dsPIC33EPXXXGP50X, dsPIC33EPXXXMC20X/50X and PIC24EPXXXGP/MC20X Family Silicon Errata and Data Sheet Clarification

The dsPIC33EPXXXGP50X, dsPIC33EPXXXMC20X/50X and PIC24EPXXXGP/MC20X family devices that you have received conform functionally to the current Device Data Sheet (DS70000657J), except for the anomalies described in this document.

FIGURE 1: TIMING DIAGRAMS FOR CENTER-ALIGNED AND EDGE-ALIGNED MODES

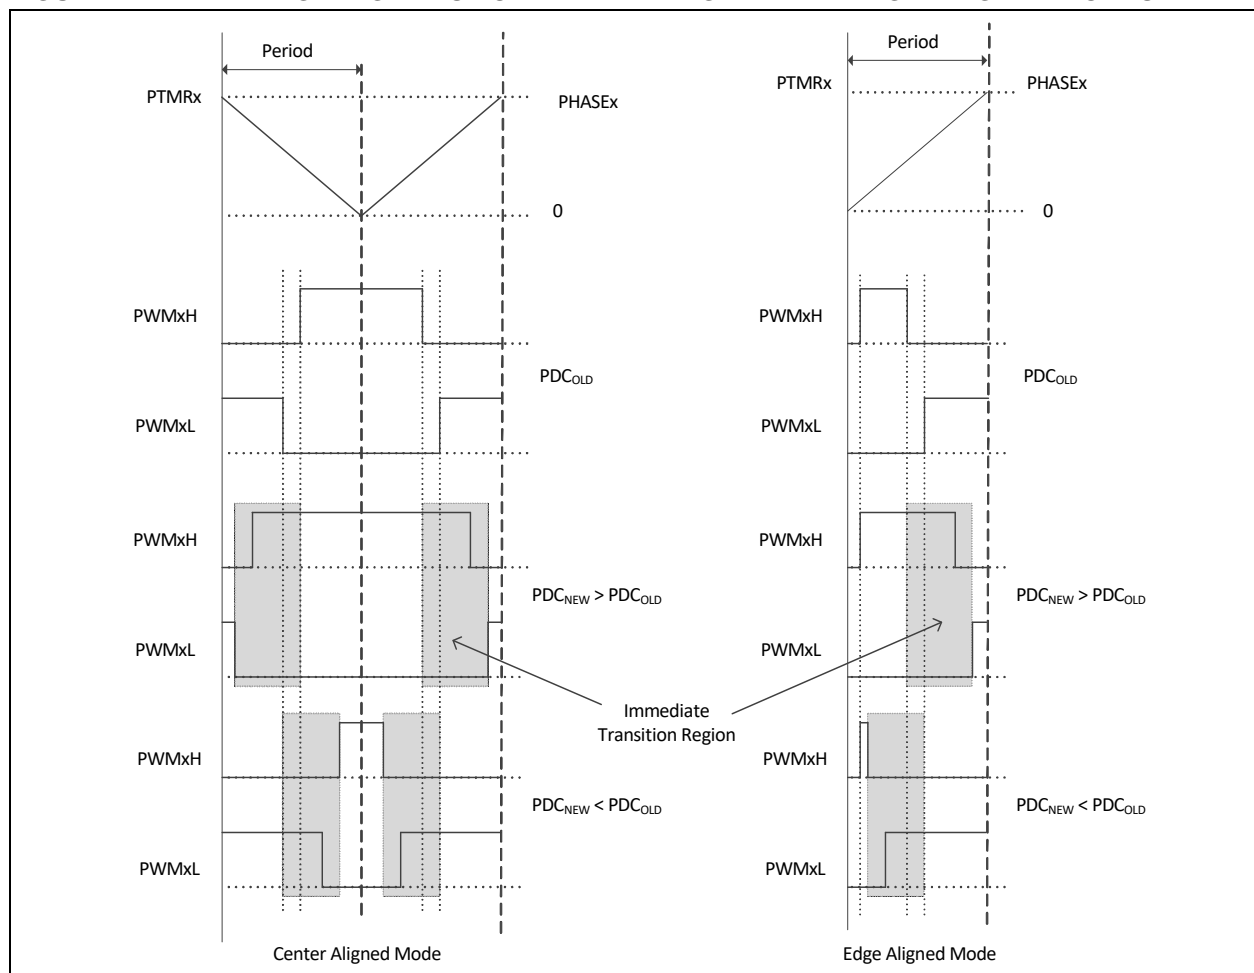
The PWM generator may not assert dead time on the edges of transitions. This has been observed when all of the following conditions are present:

- The PWM generator is configured to operate in Complementary mode with Independent Time Base (ITB) or master time base;
- Immediate update is enabled; and
- The value in the PDC register is updated in such a manner that the PWMxH and PWMxL outputs make an immediate transition.

The current duty cycle, PDC_{OLD}, newly calculated duty cycle, PDC_{NEW}, and the point at which a write to the Duty Cycle register occurs within the PWM

time base, will determine if the PWMxH and PWMxL outputs make an immediate transition. PWMxH and PWMxL outputs make an immediate transition if the Duty Cycle register is written with a new value, PDC_{NEW}, at a point of time when the PWM time base is counting a value that is in between PDC_{NEW} and PDC_{OLD}. Additionally, writing to the Duty Cycle register, close to the instant of time where dead time is being applied, may result in a reduced dead time effective on the PWMxH and PWMxL transition edges.

In Figure 1, if the duty cycle write occurred in the shaded box, then PWMxH and PWMxL will make an immediate transition without dead time.

None.

However, in most applications the duty cycle update timing can be controlled using the TRIGx trigger, or Special Event Trigger, such that the above mentioned conditions are avoided altogether.

FIGURE 2: PWM TIMING DIAGRAM

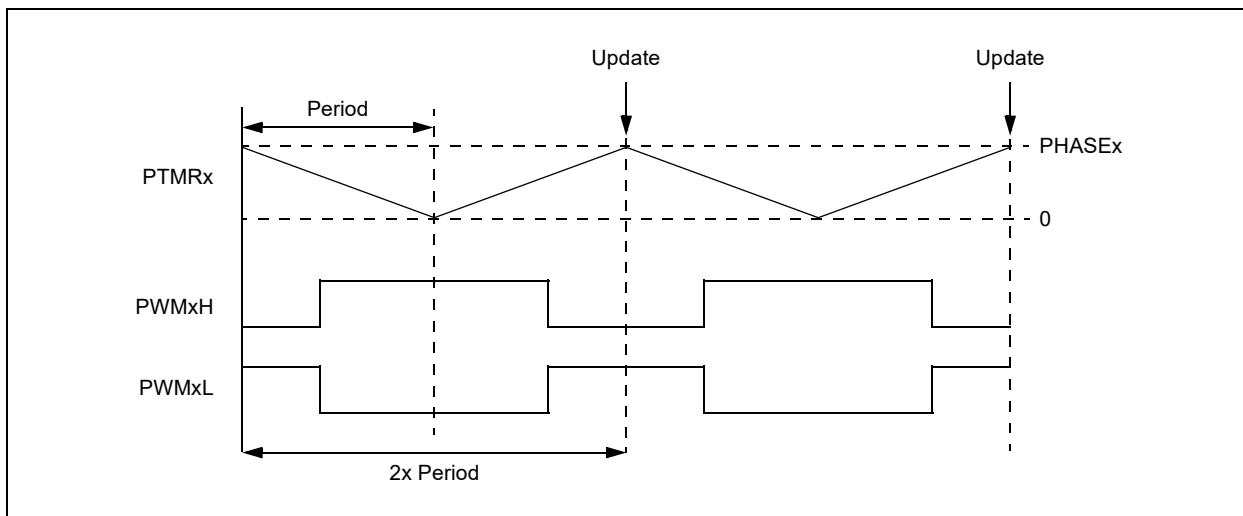
In Center-Aligned mode, updates to active `MDC/PDCx/ALTDTRx/PHASEx` registers occur only once every two PWM periods; that is, when the PWM timer matches the `PHASEx` register. In other words, the double update feature is not available. Figure 2 illustrates this relationship.

None.

FIGURE 3: CORRECT AND INCORRECT POSITION COUNT CAPTURES

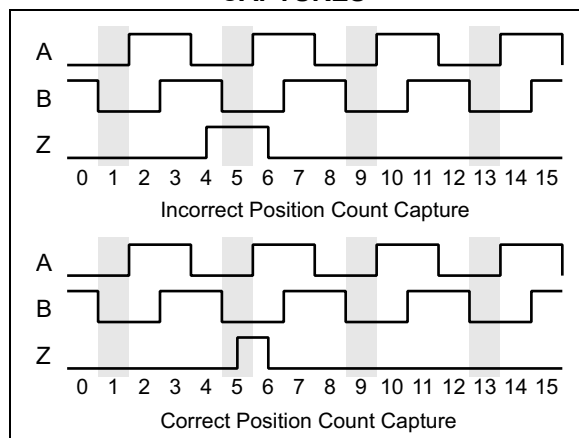
When index count position capture is being used ($QE1IOC.QCAPEN = 1$), the position count may be one more or one less than the correct value, depending on the direction of the count.

This is only observed when the leading edge of the index pulse occurs prior to the leading edge of the index match event. When the index pulse starts after the leading edge of the index match event, the position count is captured correctly.

Figure 3 shows how this occurs. In these cases, Encoder Signals A, B and (index) Z are shown, with the module being configured for index match when A and B are '0'. The effects of a correct and incorrect capture are shown side by side (shaded area indicates the index match event); the position count is shown along the bottom.

For encoder signals with timing that ensures the index pulse always starts prior to the start of the index match event (i.e., encoders with a non-gated index pulse), measure the direction of the encoder motion. If the encoder is counting up, add one to the captured position count; if the encoder is counting down, subtract one from the captured position count.

For encoder signals where the index pulse leading edge approximately coincides with the start of the index match event (i.e., encoders with a gated index pulse), a small delay can be added to the index pulse, for instance, by using a simple R-C filter.

FIGURE 4: PWM GENERATOR TIMING DIAGRAM

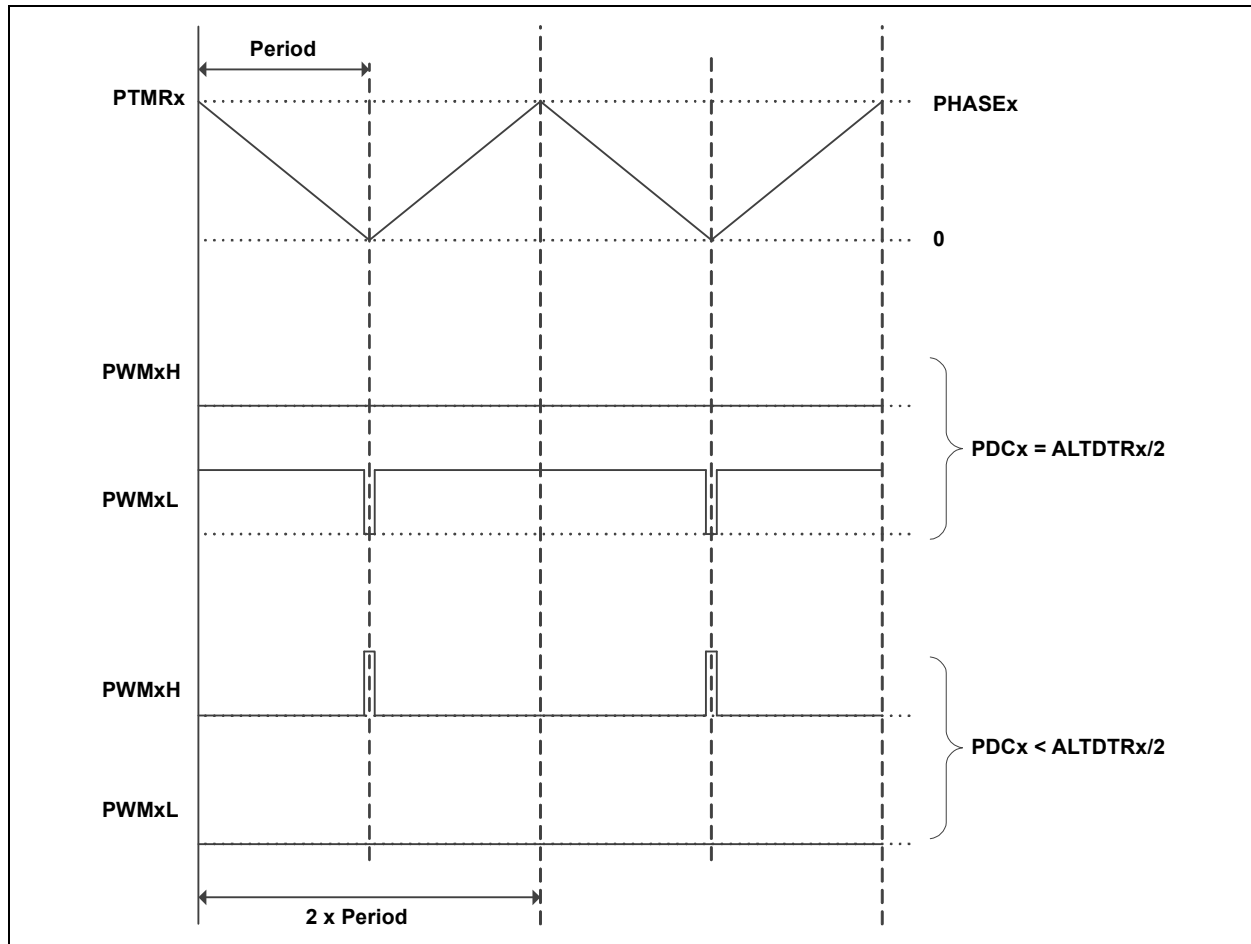
In Center-Aligned Complementary mode with Independent Time Base, if the value in the PDCx register is less than one-half the value in the ALTDTRx register, the PWM generator will force the PWMxL to low, and on the PWMxH, generate pulses of width less than twice the dead time, as shown in Figure 4.

FIGURE 5: ILLUSTRATION OF 1 T_{osc} GLITCH WHEN PWM OVERRIDE IS TURNED OFF

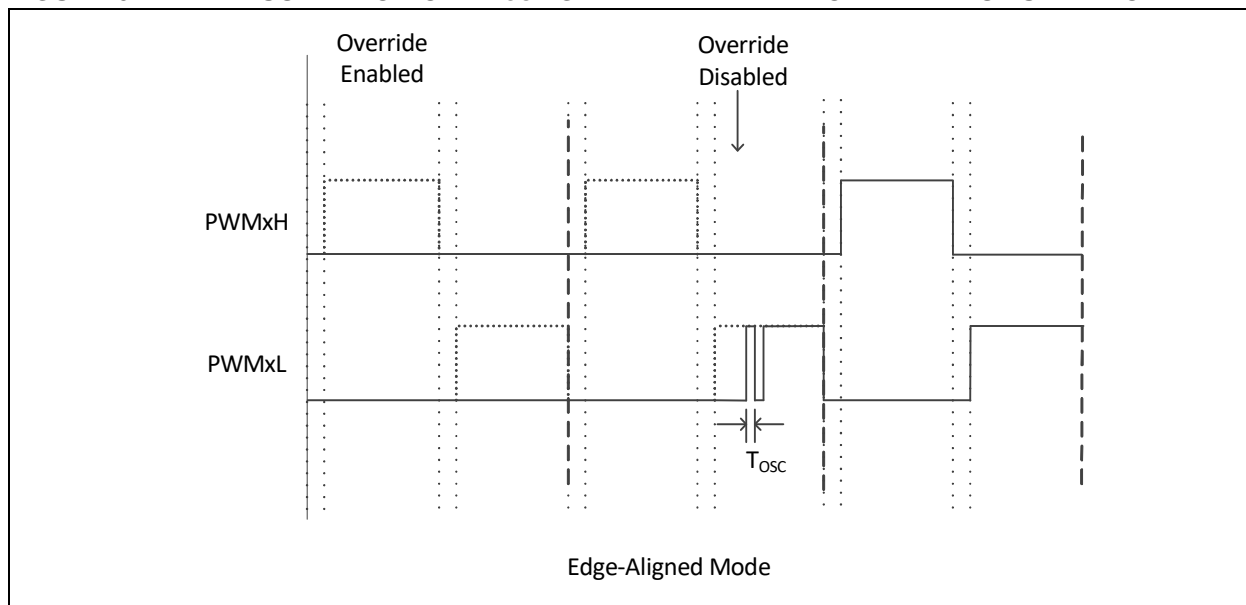
In Complementary mode after the PWMx module is enabled (PTEN = 1), if the PWM override is turned off, a 1 T_{osc} glitch will be present on the rising edge of either PWMxH or PWMxL, whichever occurs first, as shown in Figure 5. The glitch will be present on PWMxH/PWMxL every time the override state is changed from enabled to disabled. The width of this glitch is equal to 1 T_{osc} when PCLKDIV[2:0] = 000; increasing the PWM input clock prescaler setting will increase the width of the glitch accordingly.

FIGURE 6:

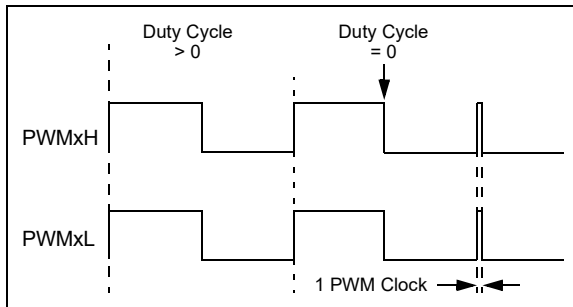
In certain output modes, the PWMx module produces a pulse glitch of one PWM clock in width (Figure 6). This has been observed only when all of the following are true:

- Either Redundant or Push-Pull Output mode is selected (IOCONx[11:10] = 10 or 01);
- Immediate Update is disabled (PWMCONx[0] = 0); and
- The value of the current Duty Cycle register (either the PDCx or MDC register, as determined by PWMCONx[8]) is updated to zero from any non-zero value.

The pulse glitch has been observed to occur at the beginning of the following PWM boundary period.

FIGURE 7:

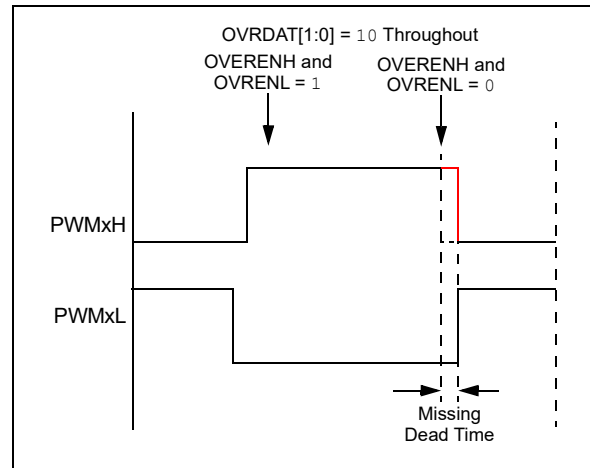
- Output override synchronization is configured to occur on the CPU clock boundary (IOCONx[0] = 0);
- Both PWMxH and PWMxL overrides are enabled prior to the event (OVRENH and OVRENL are both '1'), and
- Both overrides are disabled (OVRENH and OVRENL are both '0') at the instant the dead time should be asserted (Figure 7).

This has been observed in both Center-Aligned and Edge-Aligned modes.

FIGURE 8:

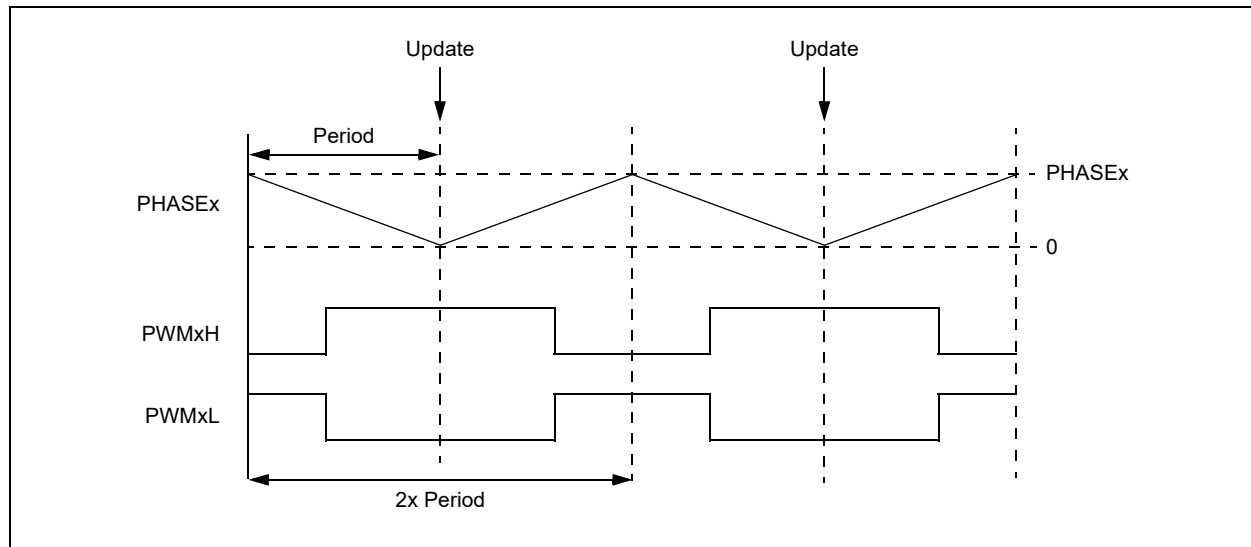
In Center-Aligned Complementary mode with Independent Time Base, updates to the PHASEx register take effect in the middle of a center-aligned PWM cycle, as shown in Figure 8. This occurs only when the Immediate Update feature is disabled (IUE = 0). If Immediate Update is enabled (IUE = 1), the PHASEx register updates will take effect immediately.

FIGURE 9: SIMPLIFIED BEHAVIOR

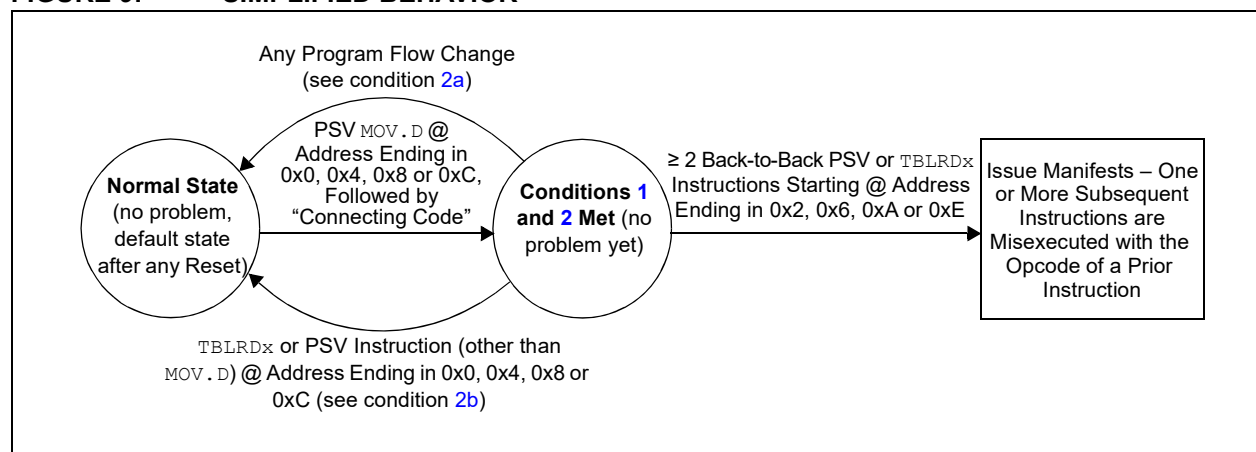
3.	≥ 2 back-to-back PSV or <code>TBLRDx</code> instructions are executed (following the code of condition 2), where the first of the back-to-back instructions is located at an address ending in 0x2, 0x6, 0xA or 0xE.

[Figure 9](#) provides an example of the effective behavior.

1. All instances of PSV `MOV.D` can be replaced with two PSV `MOV` instructions instead. Non-PSV `MOV.D` instructions acting on RAM/SFRs do not need to be modified; or
2. If not already present, a program flow change instruction (such as `BRA $+2`) can be inserted above back-to-back data Flash read sequences; or
3. Back-to-back data Flash read instruction sequences can be broken up by inserting a non-Flash read instruction (such as a `NOB`) in between the Flash read instructions; or
4. The alignment of the code can be shifted to avoid the required opcode location addresses.

C code built with MPLAB® XC16 Compiler, Version 1.32, or later, implements the work around by default. However, if the application uses Assembly language routines, these should be manually modified to implement the work around. Additionally, if precompiled libraries are used, these should be built with XC16 Version 1.32 or later. For additional information, please visit: www.microchip.com/erratum_psrds_psrds.
